Reference: C.N.492.2007.TREATIES-1 (Depositary Notification)

CUSTOMS CONVENTION ON CONTAINERS, 1972
GENEVA, 2 DECEMBER 1972

PROPOSAL OF AMENDMENTS TO ANNEXES 1 AND 4 OF THE CONVENTION

Containers with sliding sheets

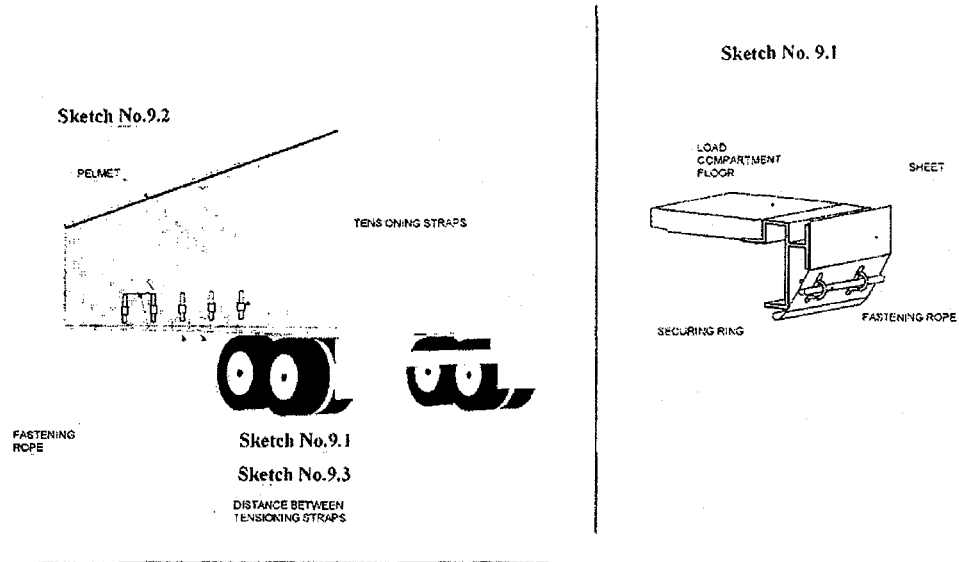
Replace the text of Article 5 by the following:

1. Where applicable, the provisions of Articles 1, 2, 3 and 4 of these Regulations shall apply to containers with sliding sheets. In addition, these containers shall conform to the provisions of this article.

2. The sliding sheets, floor, doors and all other constituent parts of the container shall fulfil either the requirements in Article 4, paragraphs 6, 8, 9 and 11 of these Regulations or the requirements set out in (i) to (vi) below.

- (i) The sliding sheets, floor, doors and all other constituent parts of the container shall be assembled in such a way that they cannot be opened or closed without leaving obvious traces.

- (ii) The sheet shall overlap the solid parts at the top of the container by at least 1/4 of the actual distance between the tensioning straps. The sheet shall overlap the solid parts at the bottom of the container by at least 50 mm. The horizontal opening between the sheet and the solid parts of the container may not exceed 10 mm measured perpendicular to the longitudinal axis of the container at any place when the container is secured and sealed for Customs purposes.

- (iii) The sliding sheet guidance and other movable parts shall be assembled in such a way that closed and Customs sealed doors and other movable parts cannot be opened or closed from the outside without leaving obvious traces. The sliding sheet guidance and other movable parts shall be assembled in such a way that it is impossible to gain access to the container without leaving obvious traces. The system is described in sketch No. 9 appended to these Regulations.

- (iv) The horizontal distance between the rings, used for Customs purposes, on the solid parts of the container shall not exceed 200 mm. The space may, however, be greater but shall not exceed 300 mm between the rings on either side of the upright if the construction of the container and the sheets is such as preventing all access to the container. In any case, the conditions laid down in (ii) above shall be complied with.

- (v) The distance between the tensioning straps shall not exceed 600 mm.
 - (vi) The fastenings used to secure the sheets to the solid parts of the container shall fulfil the requirements in Article 4, paragraph 9 of these Regulations."

Sketch No. 9

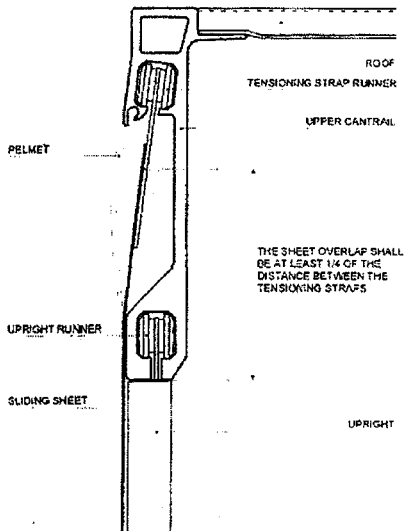
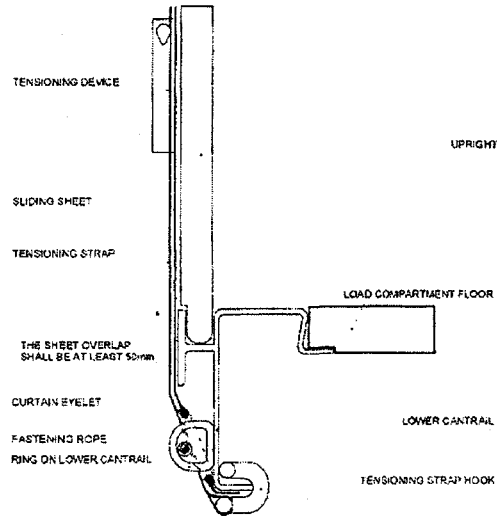
Add the following new sketch to the existing sketches appended to Annex 4, Part I :

EXAMPLE OF A CONSTRUCTION OF A CONTAINER WITH SLIDING SHEETS

Sketch No. 9.2
SHEET GUIDANCE AND OVERLAP-TOP

Sketch No. 9.3
SHEET OVERLAP-BOTTOM
